Appendix 23: Government Comments

SFMP# 3 Government Review Comments

Fort St John Pilot Project

Collation of technical input received for the draft SFMP# 2 and Participant Responses

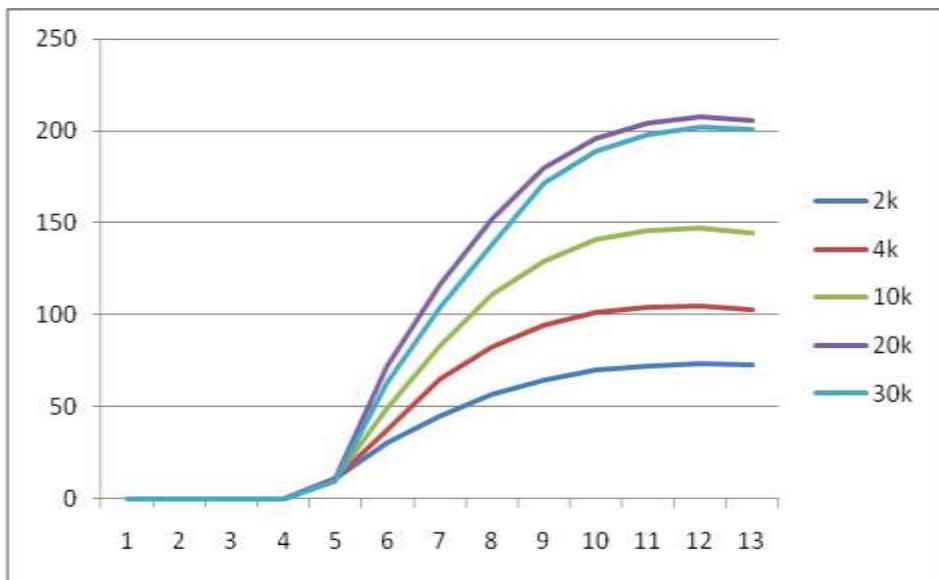
A stocking level of 4,000 st/ha total stems in these simulations would not reach a minimum merchantable volume of 140 m³/ha. With 10,000 st/ha, this would be achieved at 90 years, and at 20,000 stem/ha before year 70.

The Code Pilot SFM should be providing regeneration assessments which are consistent with current TSR analysis (e.g. 140 m³/ha minimum merchantable stand), and are supported by modelling tools which are currently available. “

- **The Timber Supply Analysis report for Fort St. John (June 2002) used >120 m³/ha as the minimum criteria for aspen stands (Table A-15), and OAF 1 / OAF 2 values of 15% and 5% respectively for assumptions in managed stands.**
